**GENWAL**  
RESOURCES, INC.

April 14, 1995

#2  
ACT/005/032  
95E

Genwal Resources, Inc. is hereby applying for a minor amendment to their Mining and Reclamation Plan, which will allow us to extend our existing warehouse. Genwal desires to add a 20 x 40 foot extension to the southeast corner of the warehouse (Figure 5-3). The extension is needed to house spare parts for the mining equipment.

Proposed  
Warehouse  
extension

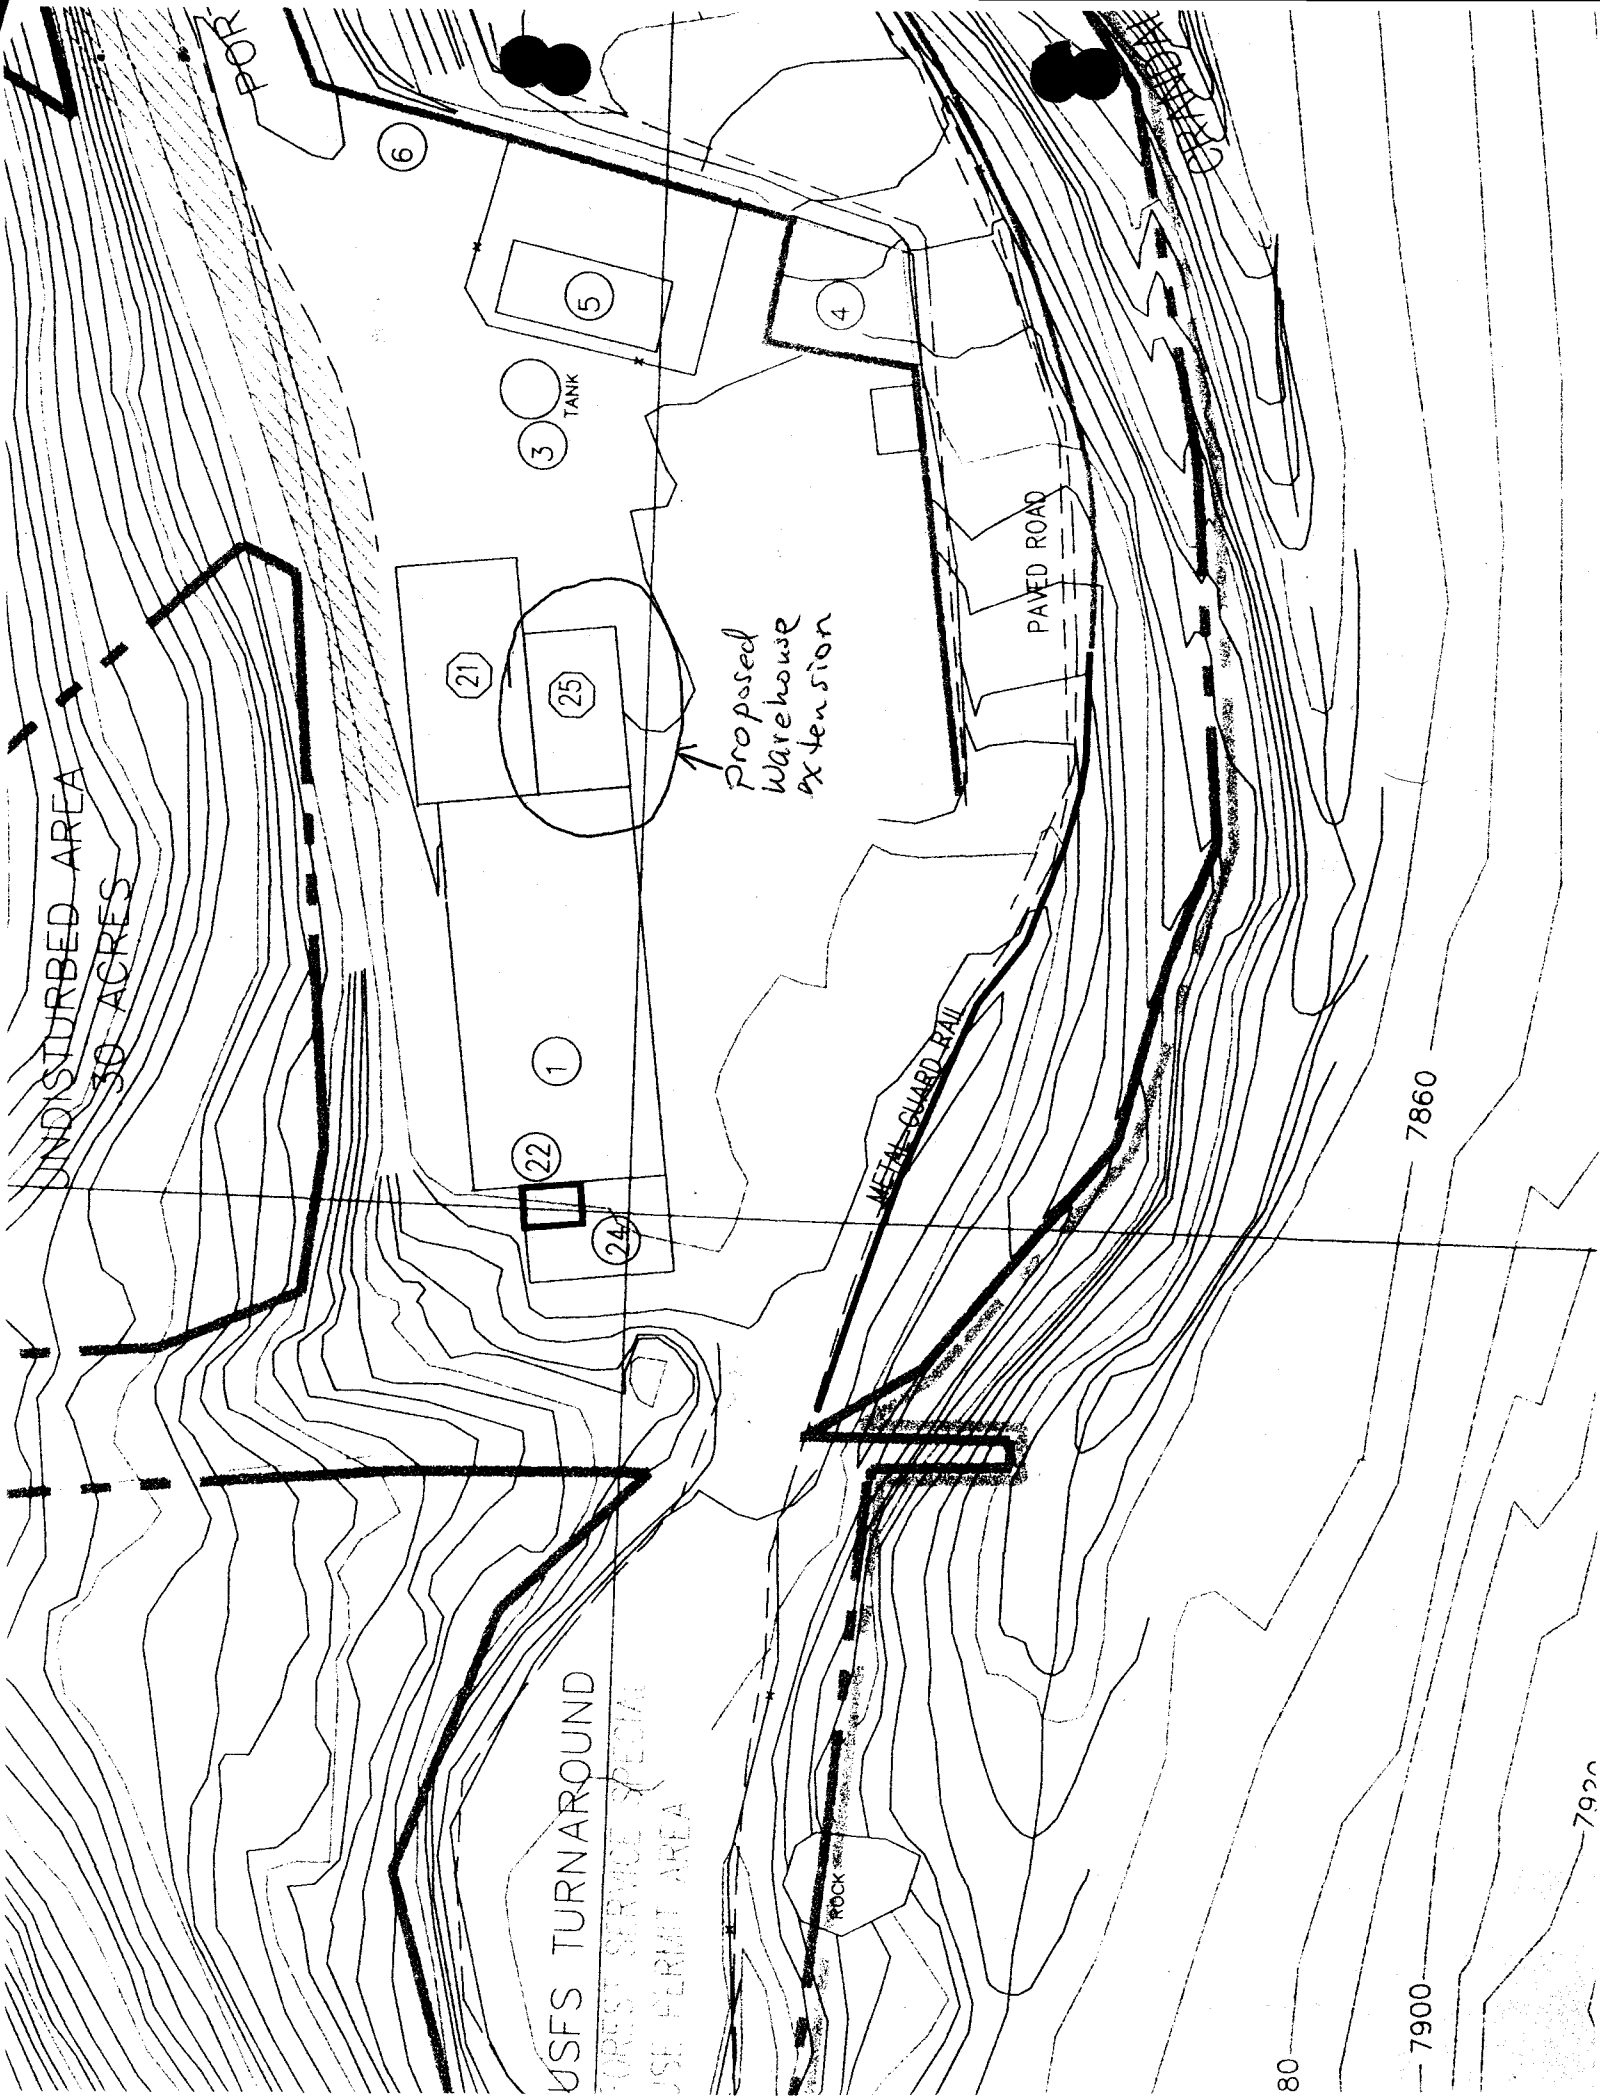
Genwal is proposing a steel framed and sided building, resting on a concrete foundation, with a 6" slab-on-grade concrete floor, reinforced with woven-wire mesh. Installation of the floor, footings and foundation will require approximately 20 cubic yards of concrete.

Runoff from the disturbed area will not increase since the building extension is being placed on an existing impervious area currently covered by asphalt. Runoff from the area is collected in the existing sediment pond.
